CITY PLANNING COMMISSION

- APPLICATION:**
- A. Variance to locate 22 of 52 required parking spaces off-site (Section 6-A-12)
 - B. Variance to locate required parking maneuvering space off-site on an adjacent parcel (Section 6-C-1)

LOCATION: 1212 Alhambra Boulevard

PROPOSAL: The applicant is requesting the necessary entitlements to expand an existing restaurant.

1 SITE PLAN
 1/4" = 1'-0"
 NORTH

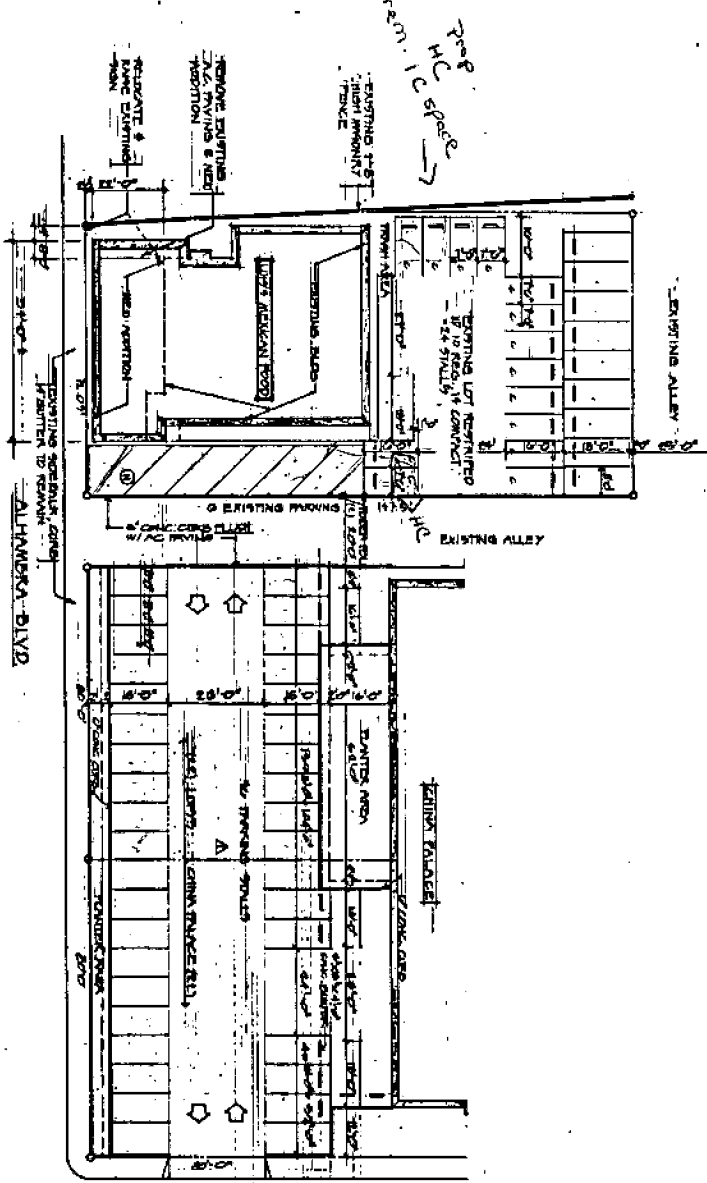
- B. The applicant is also revising on-site parking by restriping the parking area behind the existing restaurant and removing approximately five illegal spaces in front of the structure. The revised on-site parking plan consists of six existing spaces on the north side of the site and 24 stalls at the rear of the site. Access to the parking on the far west side of the site (nine spaces) is to be provided from a private driveway and therefore a variance to allow required maneuvering space off-site is requested. At the present time, there is a guideline wire for a utility pole located on the corner of the alley and the private driveway. This line obstructs three proposed parking spaces, however, the applicant has indicated that the utilities will be placed underground.

- C. The revised on-site parking will be developed with 48% compact spaces, however, the total compact parking for all 52 spaces is only 27%.
- D. The City Traffic Engineer has reviewed the applicant's plans and has the following comments:

- 1. All existing abandoned driveways shall be removed and the curb and sidewalk shall be restored.
 - 2. A visible separation shall be provided between the alley and parking lot.

- 3. A planter or barrier shall be constructed along all sidewalks except at driveways.
 - 4. All sidewalks shall be repaired as may be necessary (subject to on-site inspection at completion of construction).

- E. The site plan indicates that an open trash area will be provided along the southwest end of the existing structure. Staff recommends the trash area be enclosed with a solid masonry wall with closable metal doors. Plans for the trash enclosure shall be submitted to Planning staff for review and approval prior to issuance of a building permit.

- F. Although the off-site parking is to be located in an existing parking lot and the 50% parking lot shading is not required, the applicant was requested to upgrade existing landscaping and to provide additional landscaping on the site. This request was made by the Design Review Board at its October 3, 1984 meeting under which the project was submitted for review and comment only. The staff and Design Review Board suggested the additional landscaping in an effort to improve the appearance of the site which is a highly visible entrance into the Central City.

1. The applicant shall submit a 10 year lease agreement for the continued use of the off-site parking spaces for the review and approval of the Planning Director. The lease shall be approved prior to issuance of a building permit.

2. The existing on-site utility pole at the northwest corner of the site shall be placed underground. Plans for placing the utility underground shall be included in the construction plans for the proposed addition and parking lot modification.

3. The applicant shall satisfy each of the following conditions to the satisfaction of the Traffic Engineer, prior to issuance of a building permit:
 - a. All existing abandoned driveways shall be removed and the curb and sidewalks shall be restored.

- b. A visible separation shall be provided between the alley and parking lots.
 - c. A planter or barrier shall be constructed along all sidewalks except at driveways, and

- d. All sidewalks shall be repaired as may be necessary (subject to on-site inspection at completion of construction).
4. The applicant shall provide a trash enclosure consisting of solid masonry walls with a closable metal door. Plans for the trash enclosure shall be submitted to Planning staff for review and approval prior to issuance of a building permit.

5. The applicant shall adhere to the site plan for off-site parking; and landscape and irrigation plans shall be submitted to Planning staff for review and approval prior to issuance of a building permit.
